# Product Support Bulletin 2005-015A

## Maintenance of Way ~ Work Equipment Bulletin

**SUBJECT:** Rewiring to Prevent Accidental Brake Release  
Secure EEROM with Double-sided Tape

Spiking Machine Model 99C with PLC control  
CX Hammer  
Any Spiking Machine Model C or 99C converted to PLC control  
Two-Tie Screw Spiker (TTSS)  
Production Screw Spiker (PSS)

**Figure 1**

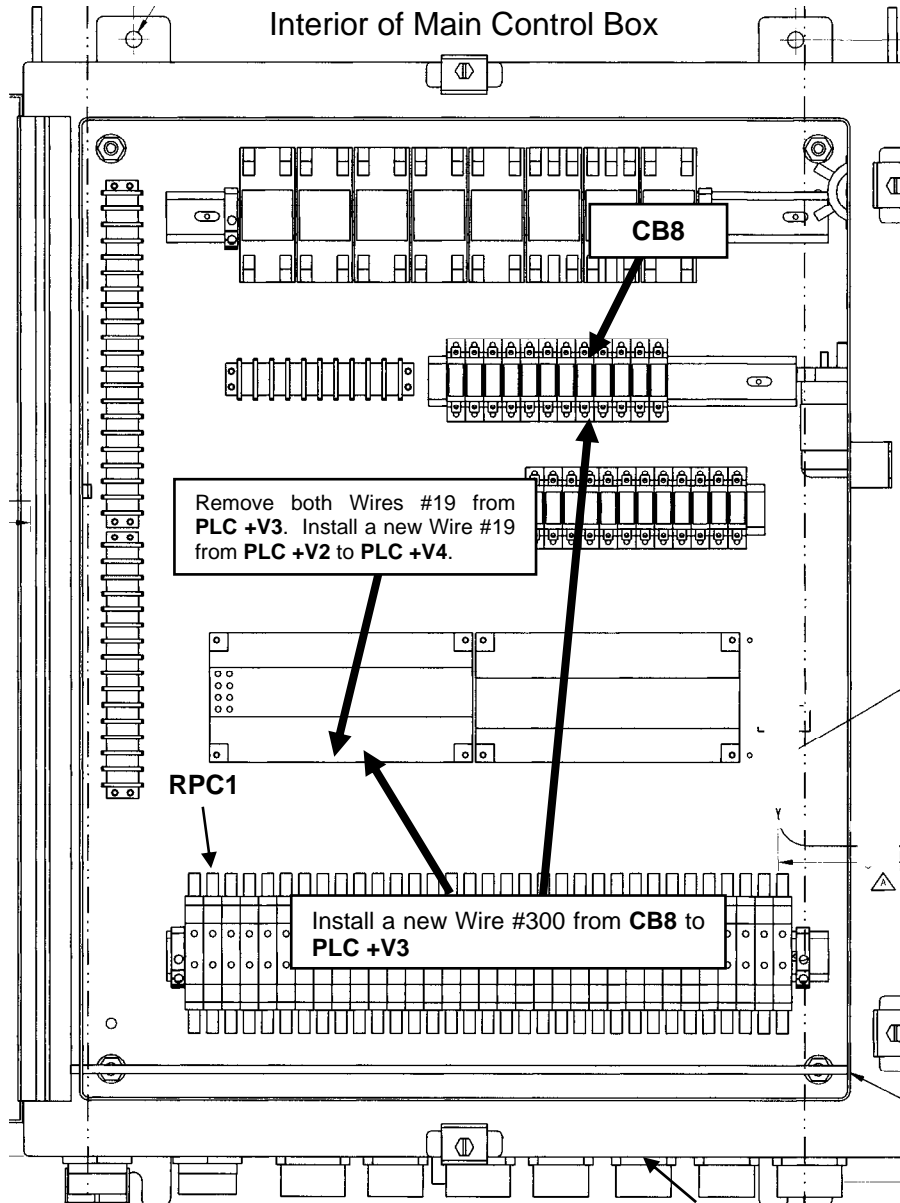
Rewire PLC +V3 from Wire #19 to Wire #300

**Figure 3**

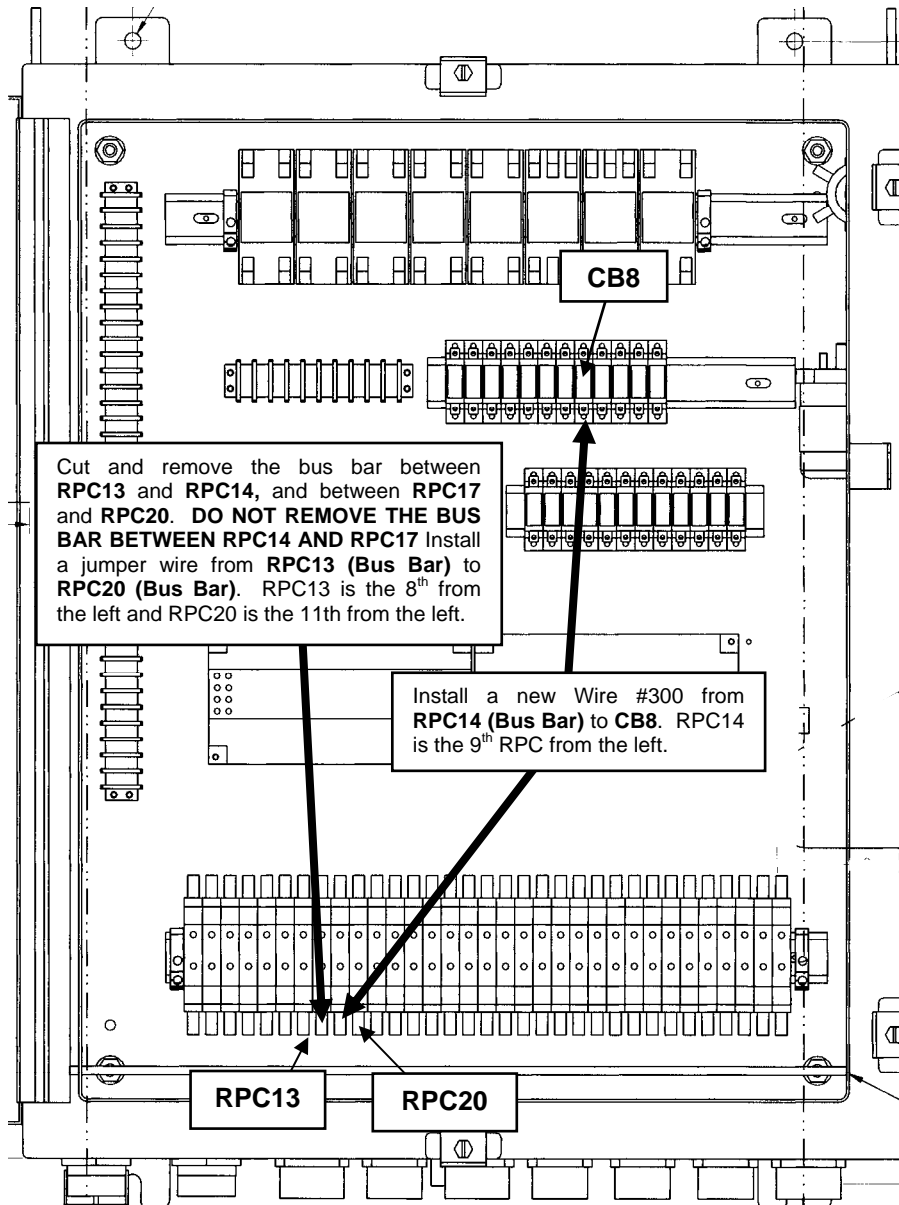
Rewire RPC14 and RPC17 from Wire #22 to Wire #300

**Figure 8**  
Typical EEPROM

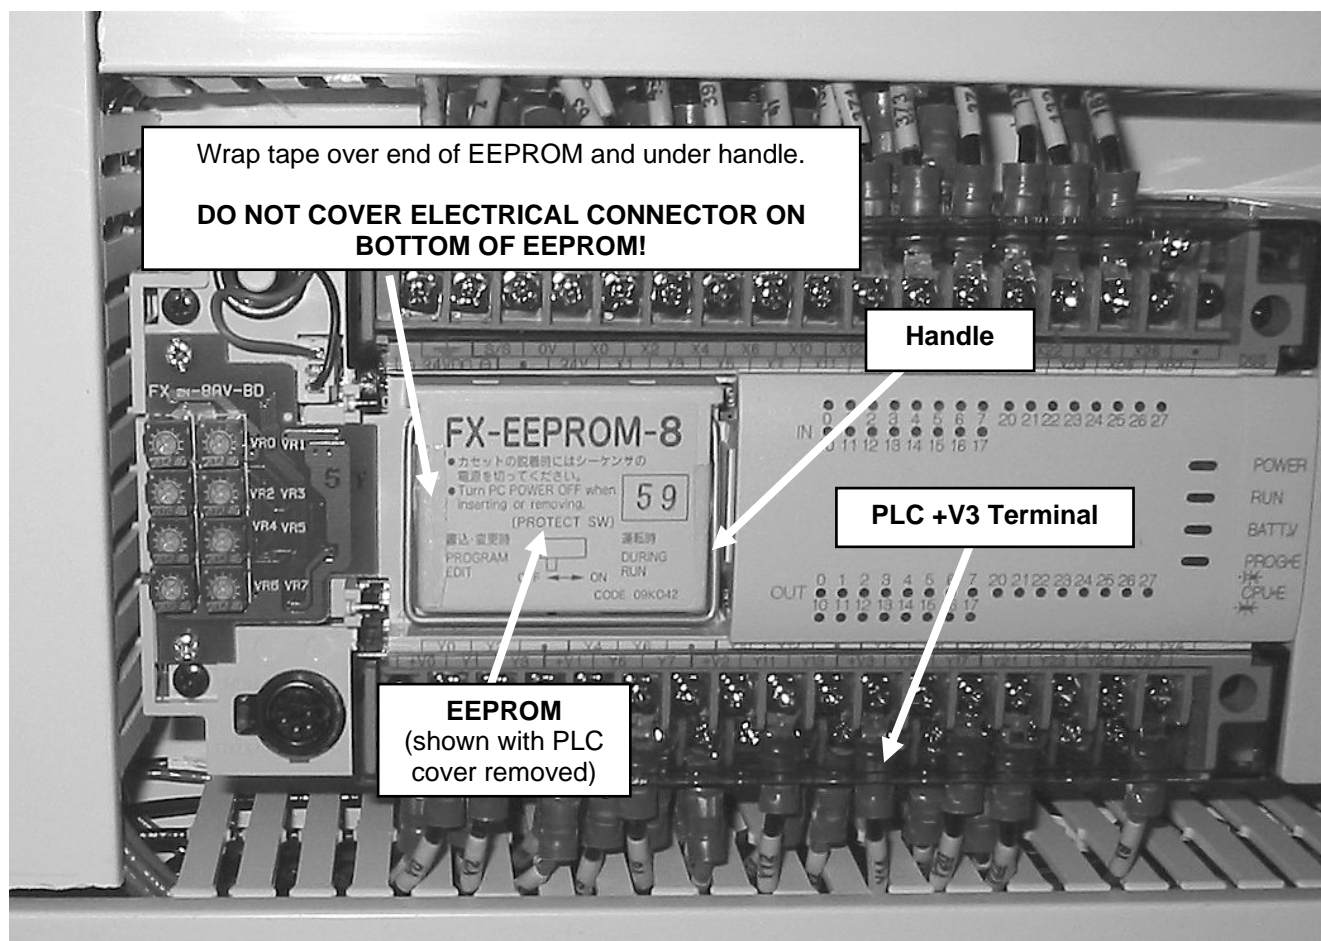
In addition, the EEPROM is to be secured to the PLC with double-sided tape. Use 3M #9576Y (yellow) or equivalent. The tape is to be wrapped around both ends as well as the back of the EEPROM. Do not cover the connector or handle with the tape. **CAUTION!** Do not apply tape at temperatures below 50°F. See Figure 8 for EEPROM location.
